HISTORIC AND DESIGN REVIEW COMMISSION

HDRC CASE NO: 2017-202
ADDRESS: 503 NOLAN
507 NOLAN
LEGAL DESCRIPTION: NCB 546 BLK 19 LOT S 126 FT OF 11
NCB 546 BLK 19 LOT S 129.86 FT OF 12
ZONING: RM-6, R-6 H
CITY COUNCIL DIST.: 2
DISTRICT: Dignowity Hill Historic District
APPLICANT: Richard Gross
OWNER: Enlour Investments
TYPE OF WORK: Exterior modifications, window replacement
REQUEST:

503 Nolan Amendment

1) Deck Levels

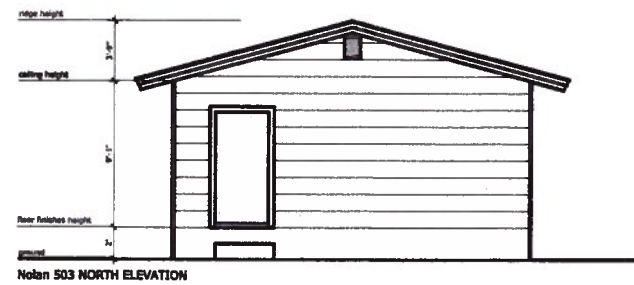
EG: QUESTIONS REGARDING EXISTING WINDOWS. ALL EXISTING
DOOR (MAIN ENTRANCE) SHOULD REMAIN. EG: QUESTIONS REGARDING
PROPOSED DECK - PROPOSED HEIGHTS SHOULD BE NOTED. A FINISH FLOOR
ELEVATION SHOULD BE ESTABLISHED. STEPS SHOULD BE CONSOLIDATED.
COMMITTEE RECOMMENDATION: APPROVE [] DISAPPROVE []
APPROVE WITH COMMENTS/STIPULATIONS:

- a. We made the deck one level and made usual stairs with rails whenever there was a difference in level between the house opening and the deck
- b. We removed the multiple levels of the deck

Back

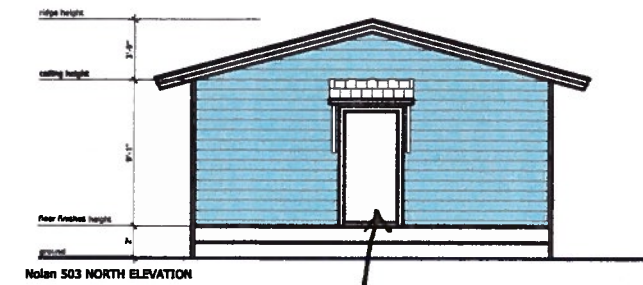
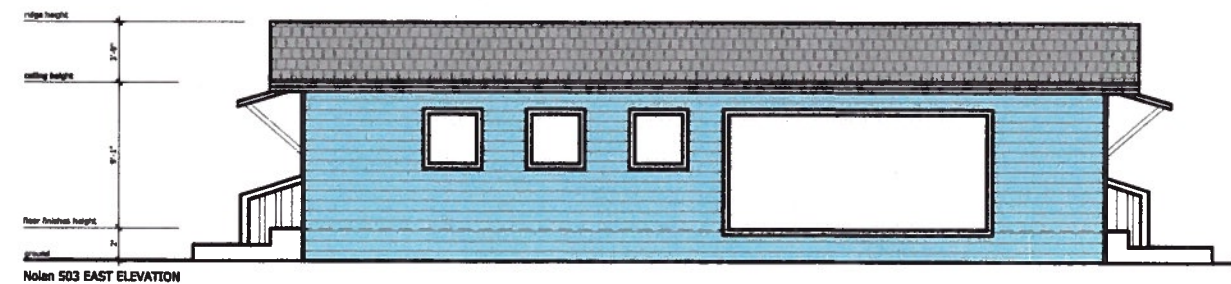
COMMENTS/CONCERNS: ALL: FOR 503, SAMPLES OR ADDITIONAL INFO
SHOULD BE PROVIDED. THE PROPOSED OPENINGS ARE VERY CONTEMPORARY.
WINDOW OPENINGS SHOULD BE CONSISTENT IN REGARDS TO PROPORTIONS.
EG: INCONSISTENCIES WITH THE CONSTRUCTION DOCUMENTS SHOULD
BE ADDRESSED.

Move door to center -
add overhang to match front
